Attachment B

Decision Table A: Staff Recommended Amendments to the Proposed Draft

Floodplain Resilience Plan

Proposed Amendment A-1: Replacement for Map 6 in the document

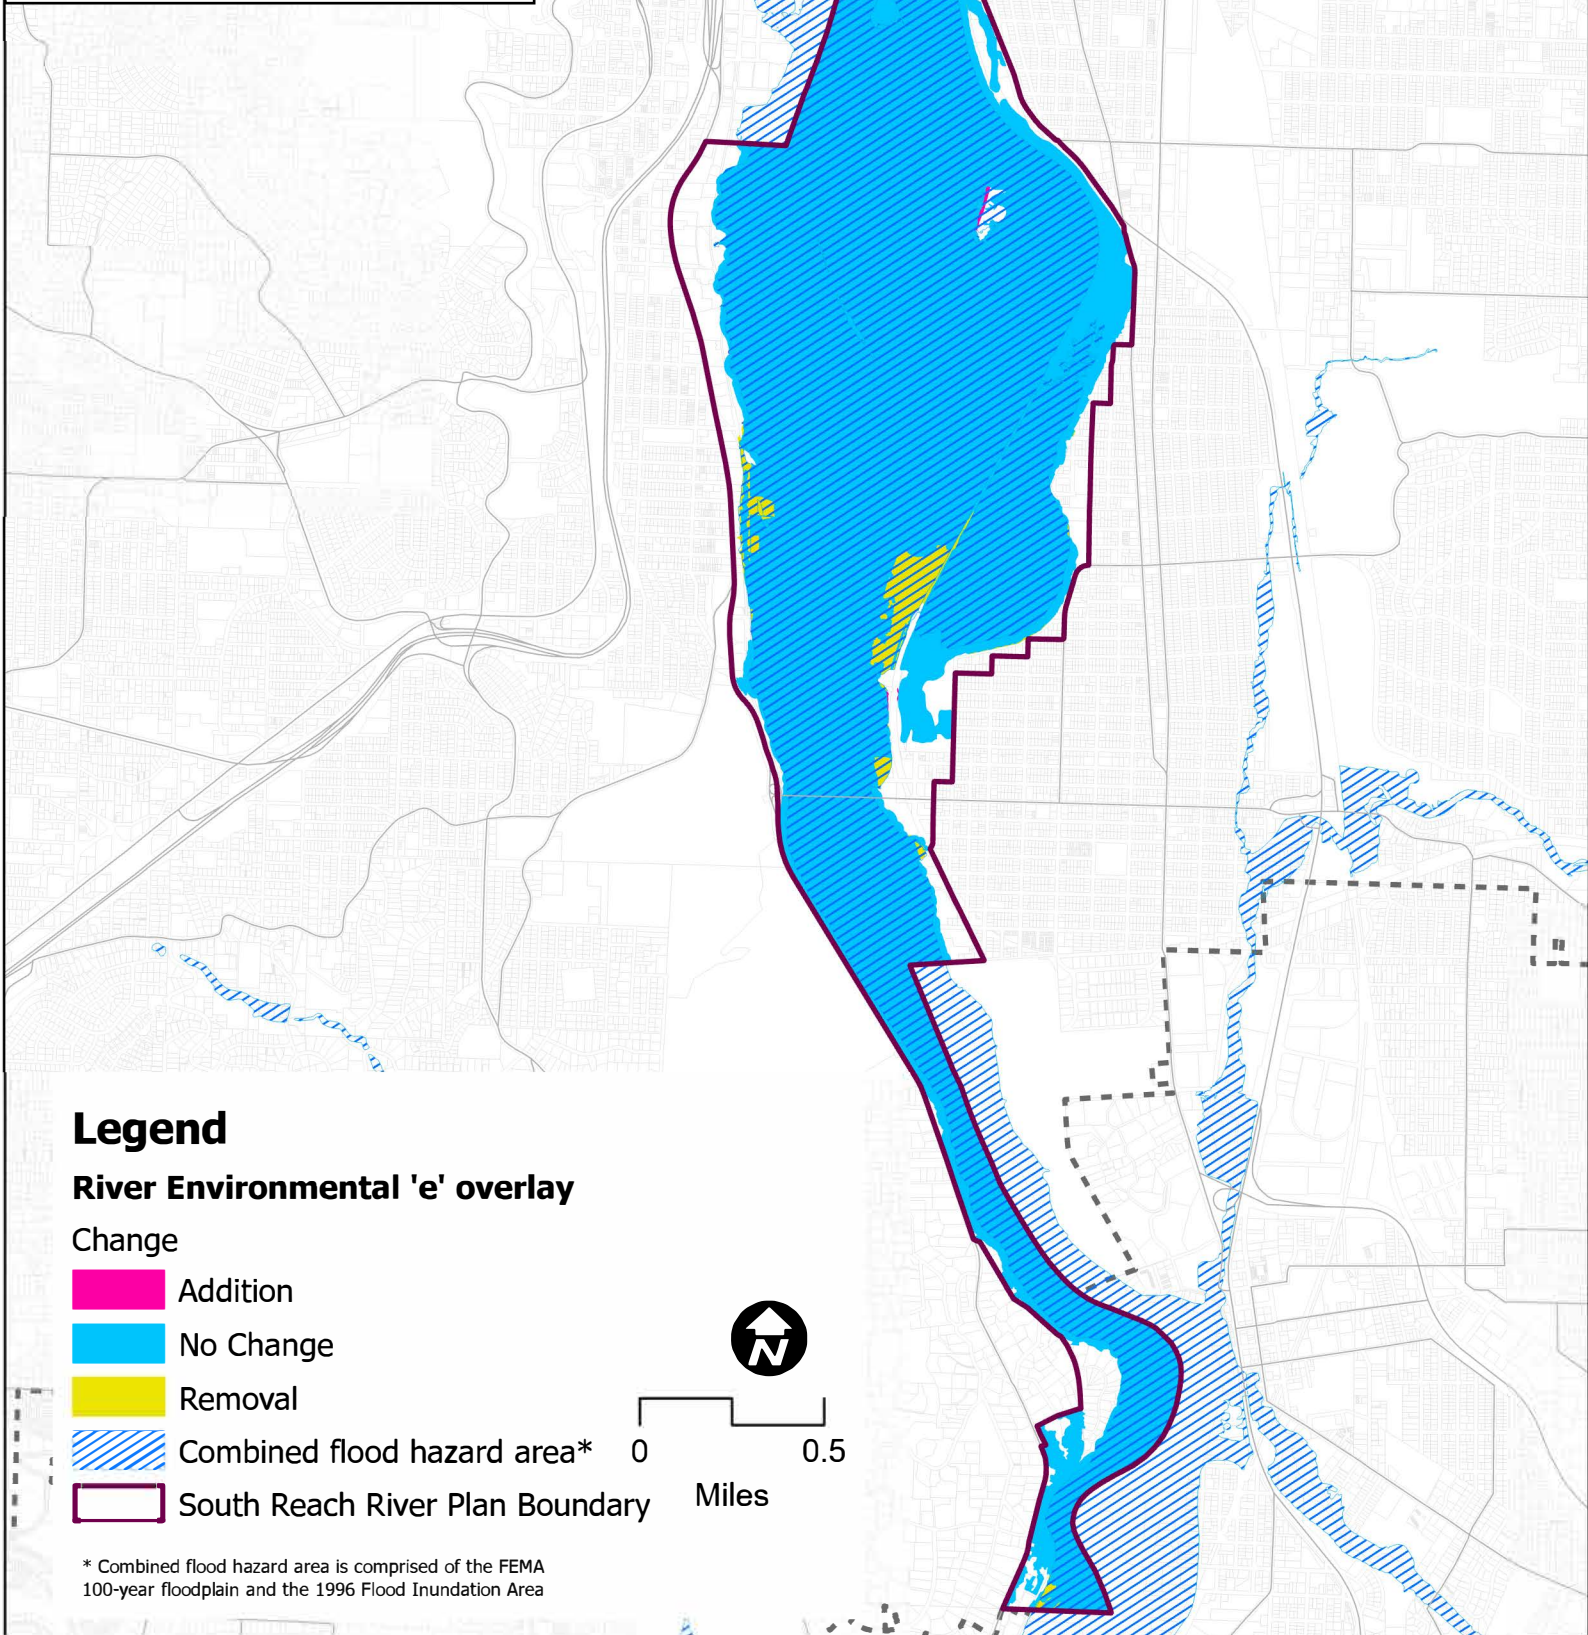
Ref #	Comment	Commenter(s)	Topic	Comment or Requested Amendment	Staff recommendation	Staff rationale	Discuss?	PSC decision
MAP AMENDMENTS								
<i>Amendments to Proposed River Environmental shown in Map 6</i>								
A-1	N/A	BPS Staff	Proposed South Reach River Environmental overlay zone	Modify the extent of the proposed River Environmental to apply it to the river setback, land within 100 feet of the top of bank, and all high- and medium-ranked riparian resources.	Replace the Map 6, Proposed changes to the River Environmental Overlay Zone in the Willamette River South Reach, on page 52 of the plan with the replacement Map 6 shown in the collection of maps in Decision Table A - Attachment 1 (see page 12).	The proposed River Environmental overlay in the Proposed Draft inadvertently removed medium-ranked riparian resources that were not in the combined flood hazard area.	<input checked="" type="checkbox"/>	<input type="checkbox"/> Support staff rec. <input type="checkbox"/> Other

Proposed Amendment A-3: Modify proposed River Environmental overlay zone and riparian buffer area

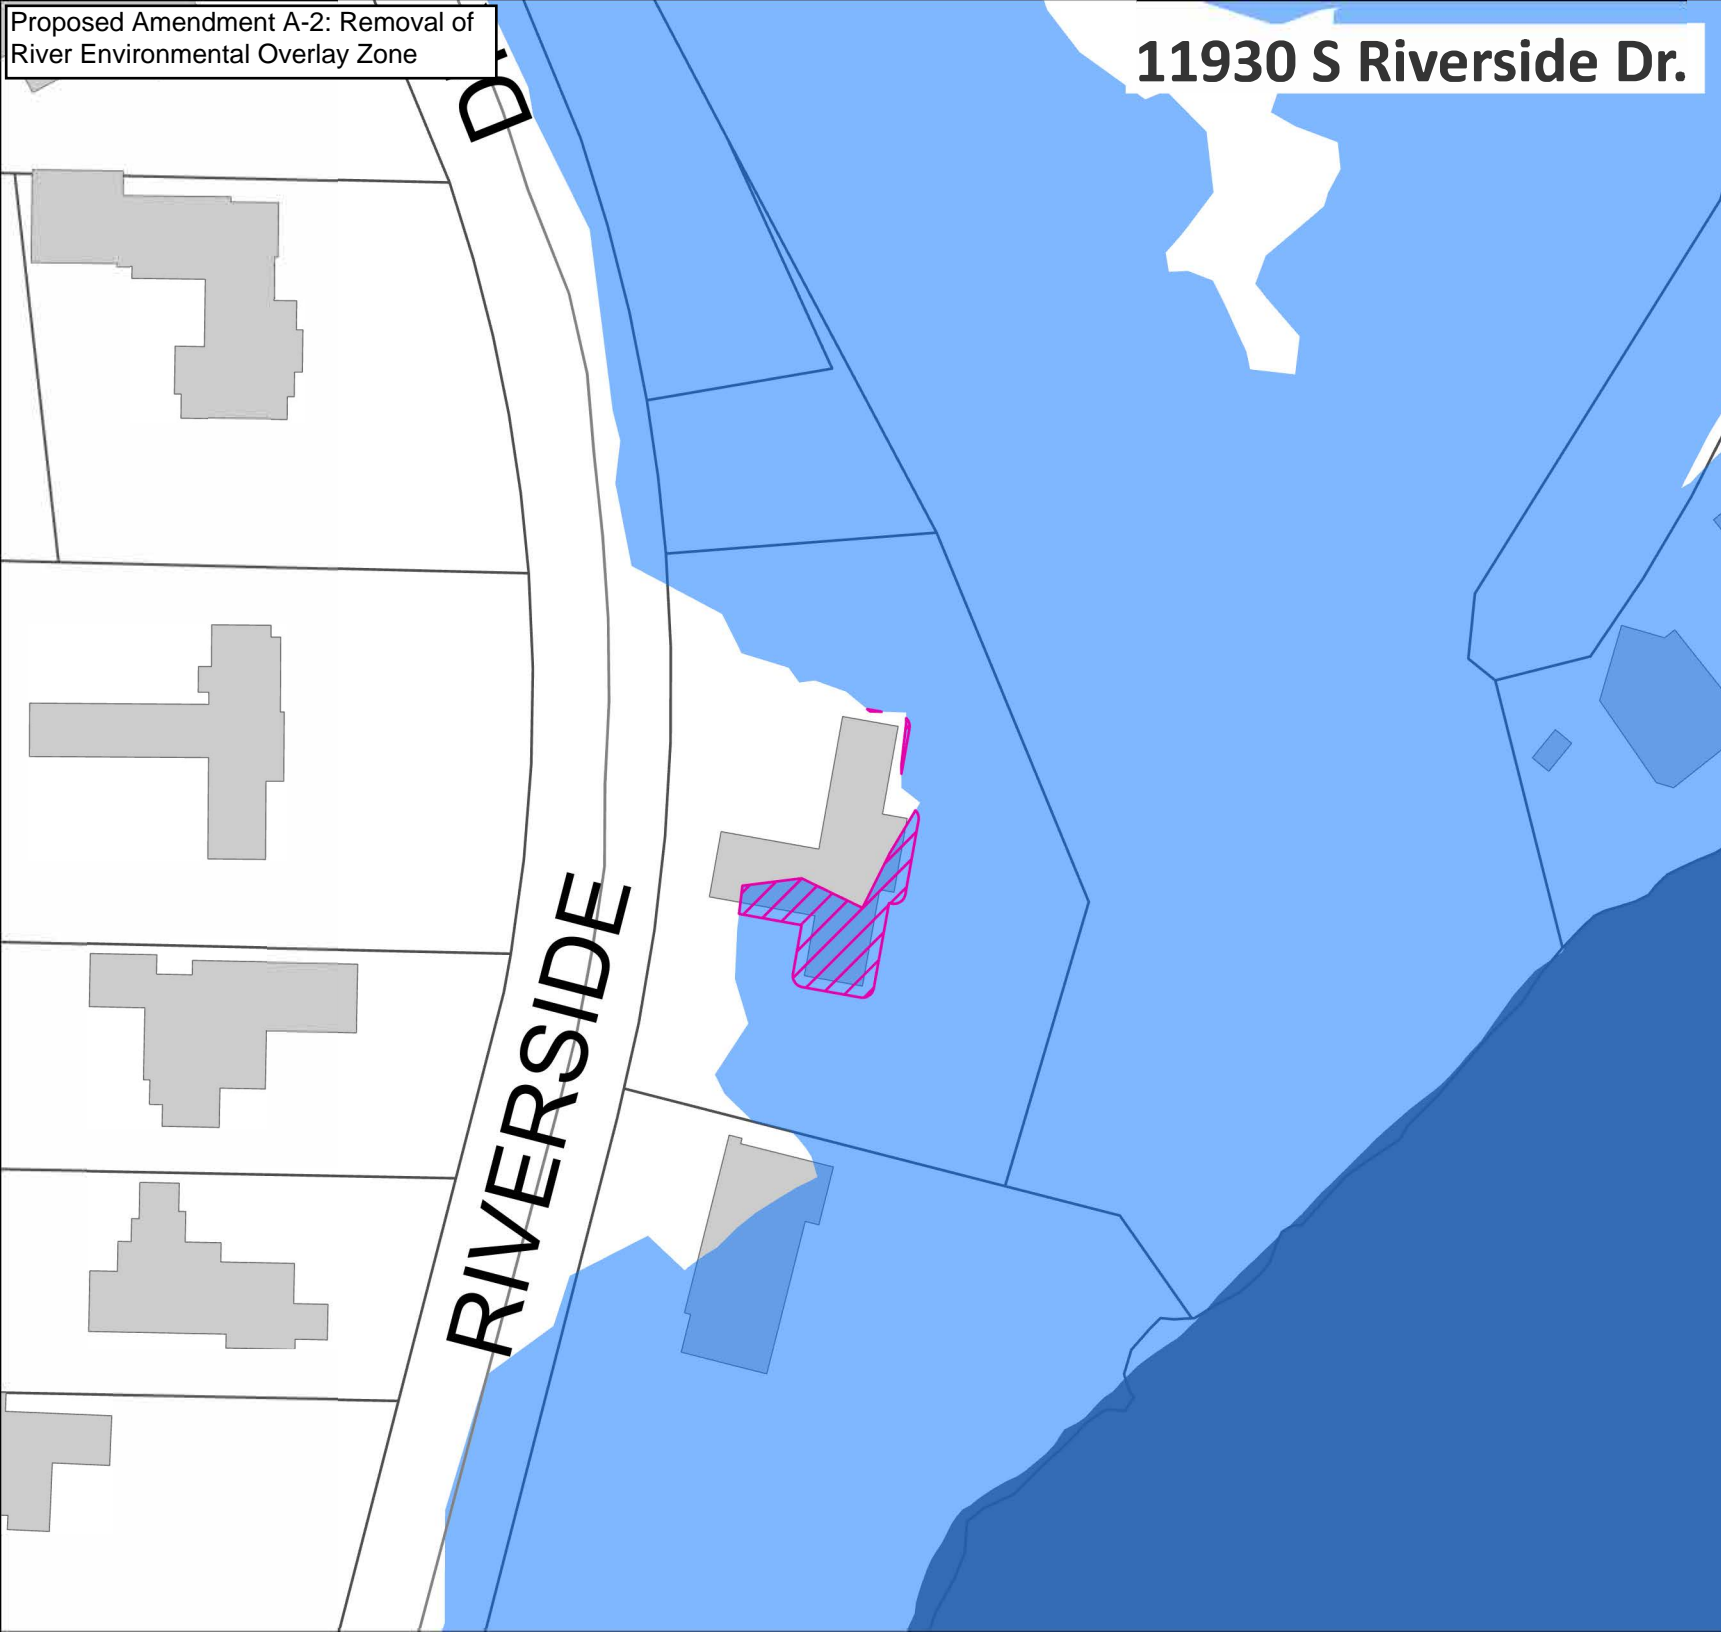
A-3	Call with BPS staff	Jim Kurtshaw	Modification of the proposed River Environmental overlay zone and riparian buffer area on Riverfront Place Condominiums site (NW Riverscape St)	Property owner at 1736 NW Riverscape St contacted City staff to request that the River Environmental overlay zone and riparian buffer area proposals be reevaluated because, as a part of the Riverscape development (around 2010), the site was removed from the FEMA 100-year floodplain through a FEMA Letter of Map Amendment based on the site characteristics.	Remove the property from the combined flood hazard area, as the FEMA 100-year floodplain is the only flood map relevant to the site (the Modeled Willamette River 1996 Flood Extent does not extend onto the property). With this modification of the combined flood hazard area, remove the proposed expansion of the River Environmental overlay zone and application of the riparian buffer area on the site. See the modification to the proposed River Environmental and riparian buffer area for this site in the collection of maps in Decision Table A - Attachment 1 (see page 14).	City staff determined that the property had been removed from the FEMA 100-year floodplain through a Letter of Map Amendment and the property should not be considered as a part of the combined flood hazard area. Therefore, the proposed expansion of the River Environmental overlay zone and application of the riparian buffer area on the site is not warranted.	<input type="checkbox"/>	<input type="checkbox"/> Support staff rec. <input type="checkbox"/> Other

Figure 510-2
South Waterfront Greenway Setback Area and Subareas

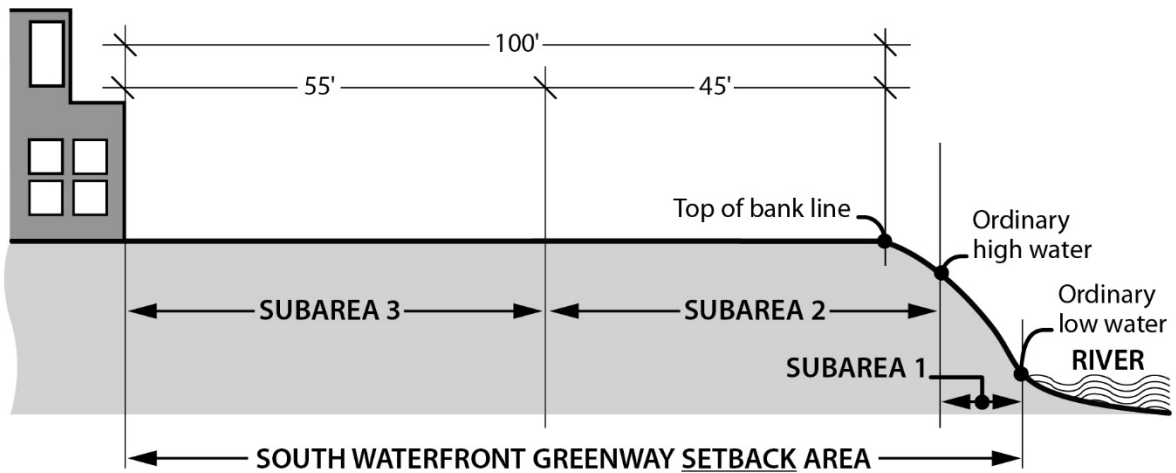
<i>Technical Amendments & Clarifications</i>								
A-11	332079	BDS Staff	Update Figure 510-2 in the South Waterfront Subdistrict (33.510.253.)	The text in Figure 510-2 should be updated throughout to include “South Waterfront Greenway <u>Setback</u> Area” throughout.	<p>Update Figure 510-2 to incorporate “setback” into the figure’s text where the “Greenway Area” is identified.</p> <p>For more detail, see Decision Table A - Attachment 2 (page 24).</p>	Not including “setback” was an oversight. It should be included in Figure 510-2.	<input type="checkbox"/>	<input type="checkbox"/> Support staff rec. <input type="checkbox"/> Other
